PLAN COMMISSION AGENDA
Village of Deerfield
2nd Floor Franz Council Chambers
April 23, 2026 at 7:30 PM
Workshop Meeting

MEMORANDUM

RE: Prefiling Conference on the Request for a Special Use Amendment to Permit the Establishment of a New School Building and Other Site Improvements for Deerfield School District 109 at Walden Elementary School at 630 Essex Court in the P-1 Public Lands District – Deerfield School District 109 and Deerfield Park District

TO: Village of Deerfield Staff & Plan Commission
FROM: CAGE Engineering / ARCON Associates, Inc. / Deerfield Public School District 109
DATE: April 2, 2026
RE: Deerfield Public School District 109 Walden Prefiling Conference Submittal

FINAL
CONDITIONS
SITE PLAN

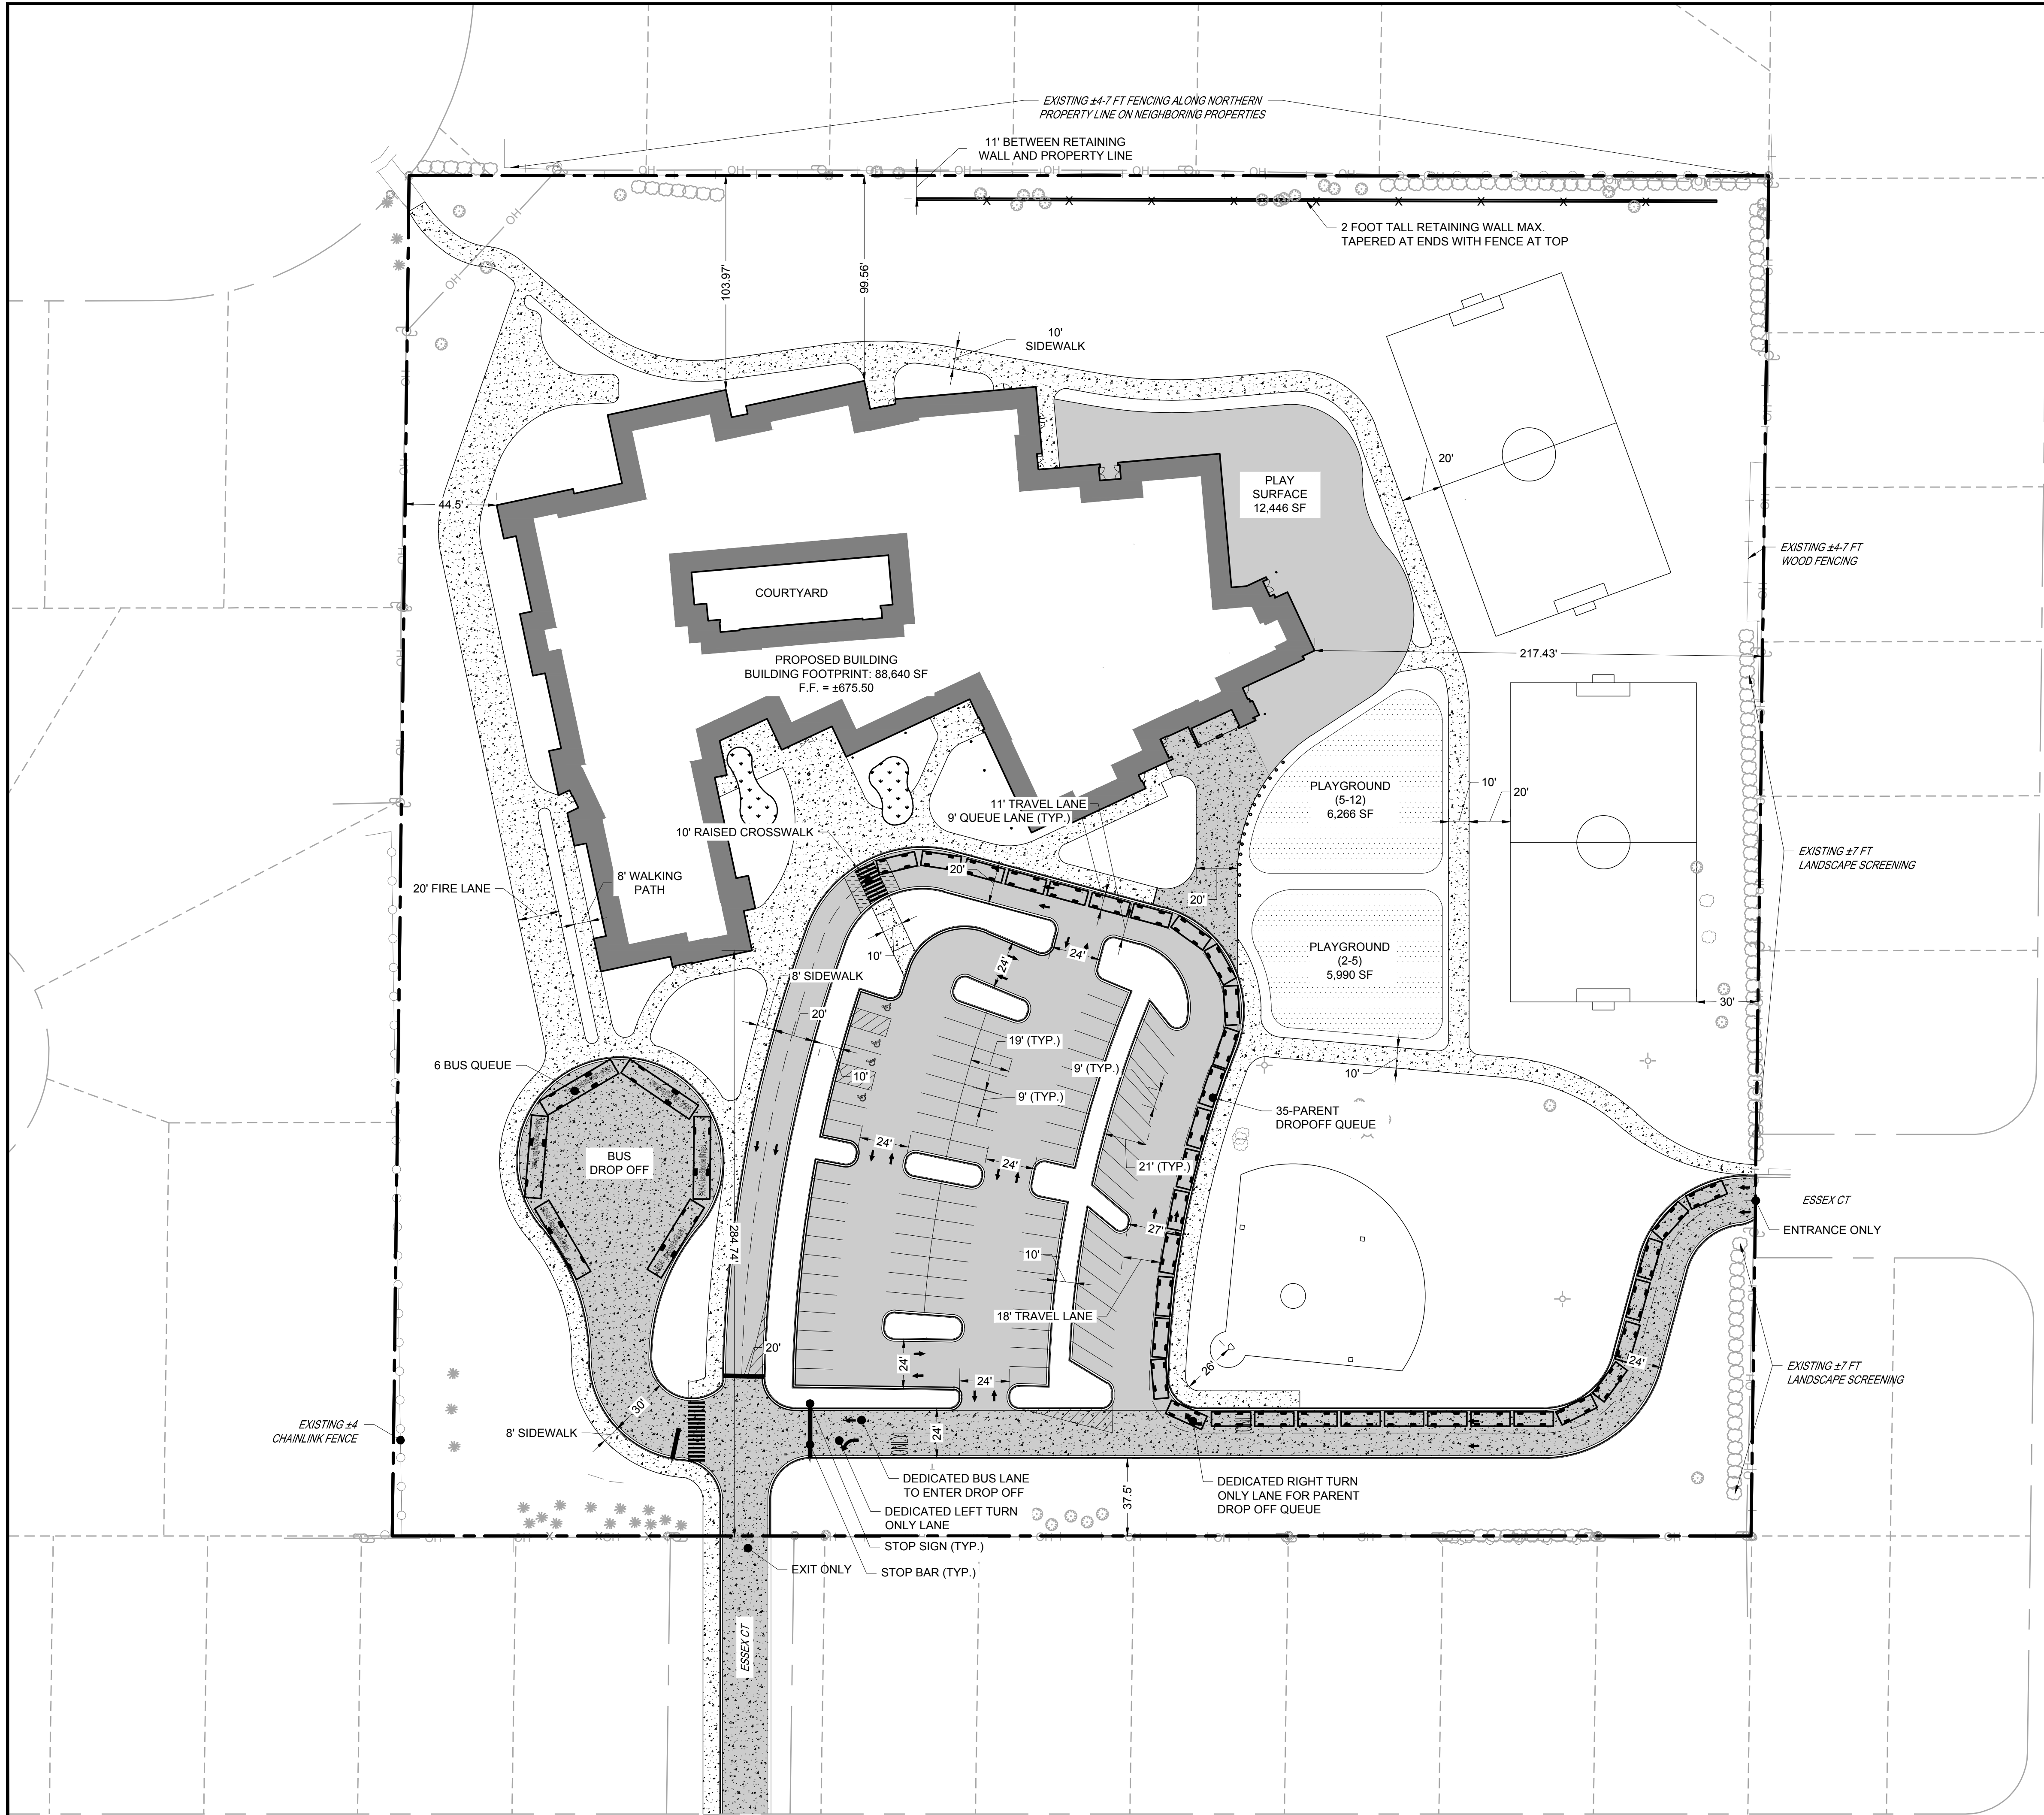
The project will continue to the Final Plan or Phase II following the completion of the new school building, and after the most recent school year is completed. Sheet EX-2 illustrates the Phase II site plan. Phase II includes the demolition of the existing school facility and redevelopment of the entire site. This phase will reconfigure parking, access, and circulation to align with the school operations. The redesigned site will provide 86 total parking spaces, a dedicated parent drop-off area with a separate right-turn lane to accommodate queuing and improve traffic flow.

The petitioners' Phase II plans show the perpendicular parking spaces will be 9 feet wide by 19 feet and the angled parking spaces will be 9 feet wide by 21 feet in depth with 24-foot drive aisles. The parking spaces and drive aisles in the new parking lot will comply with the Zoning Ordinance.

Sheet Title:
EXTERIOR ELEVATIONS

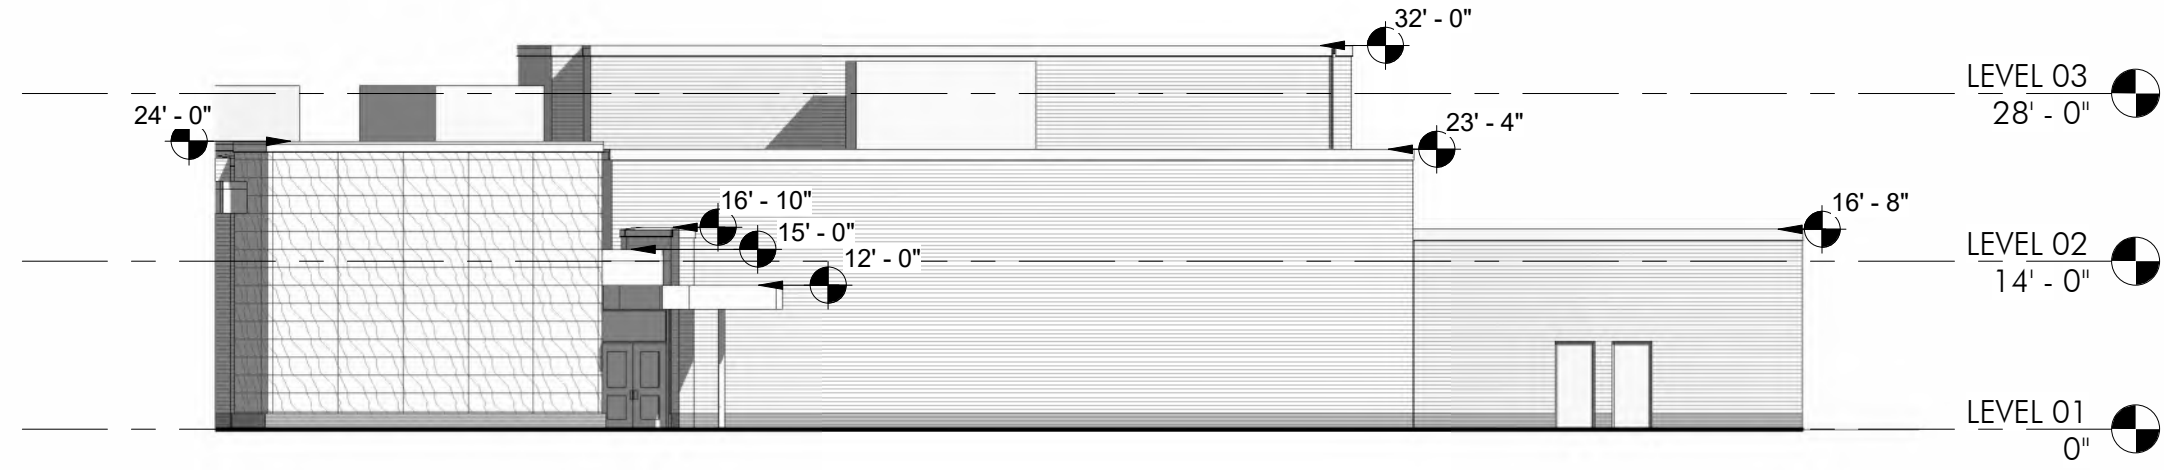
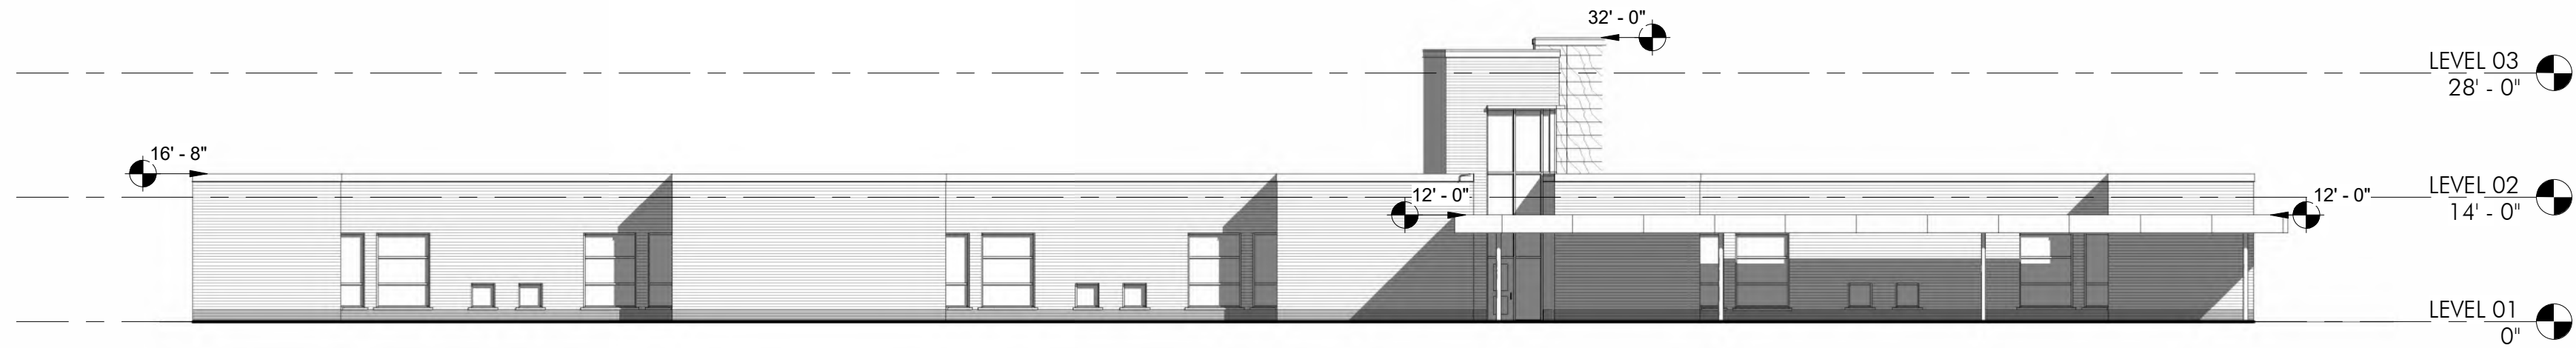
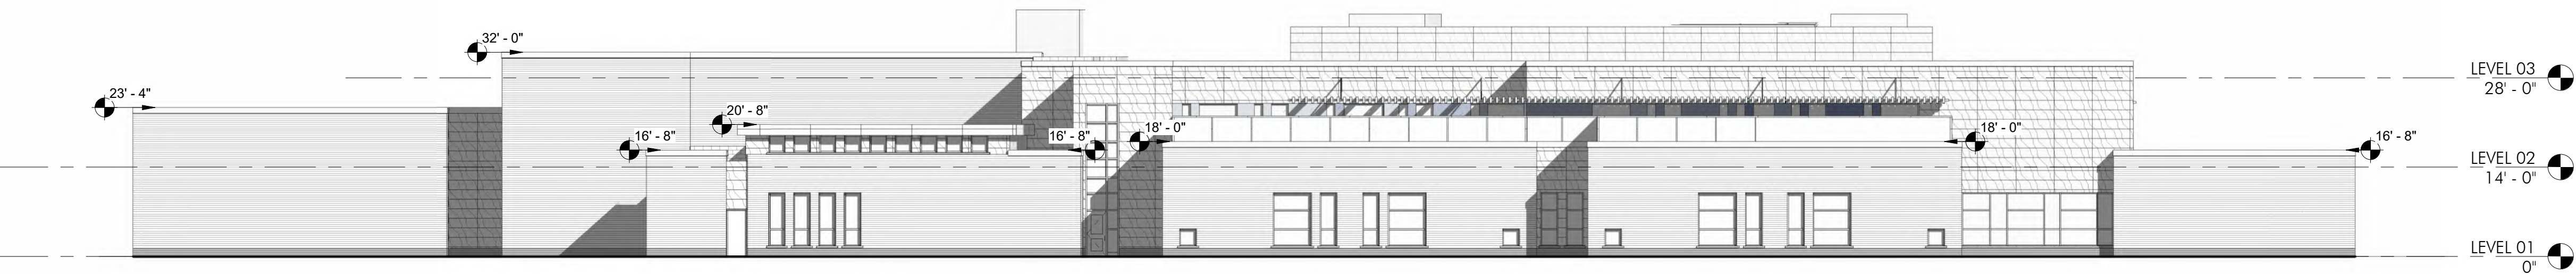
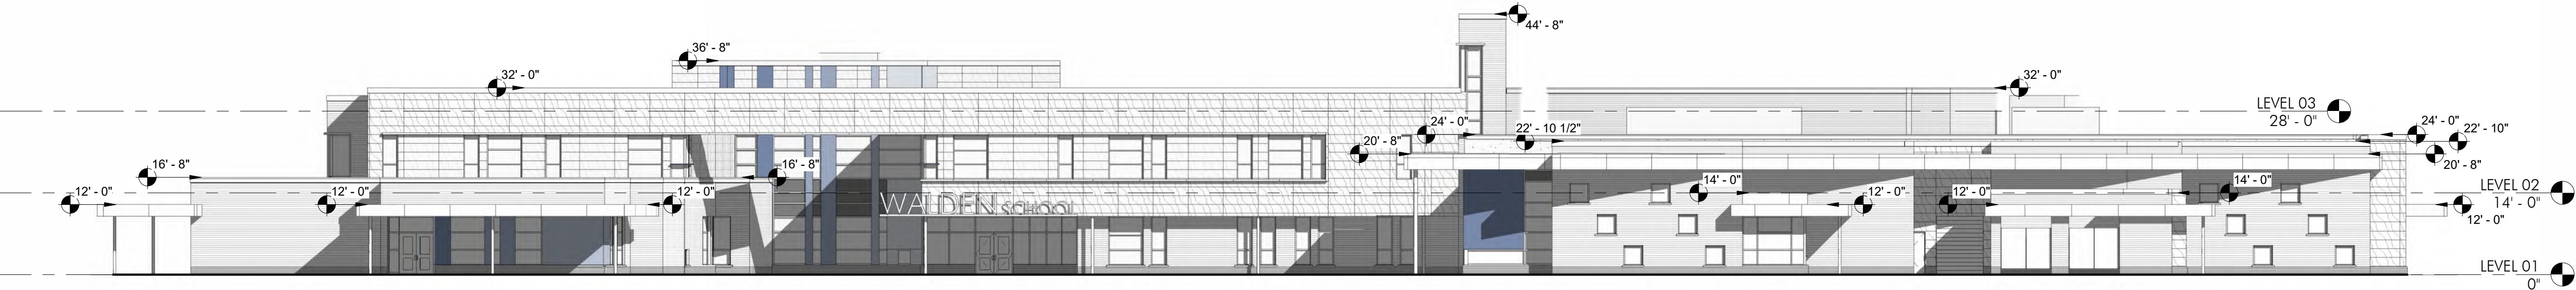
There is another portion of the proposed school building that is over the maximum 35 feet. Sheet A100 Building Elevation indicates the rooftop mechanical screening is 36 feet 8 inches. The rooftop mechanical screening is a structure designed to conceal rooftop mechanical units from ground level view. Article 2.01-D.,1. allows certain building appurtenances such as mechanical appurtenances, parapet walls, and skylights to exceed the maximum building height by not more than 12 feet. The height of the rooftop mechanical unit and its screening structure is covered under this section.

Proposed Phase I: The highest point of the proposed school building is 44 feet 8 inches and will require a height modification from the maximum height of 35 feet.

Proposed Phase II: The highest point of the proposed school building is 44 feet 8 inches and will require a height modification from the maximum height of 35 feet.
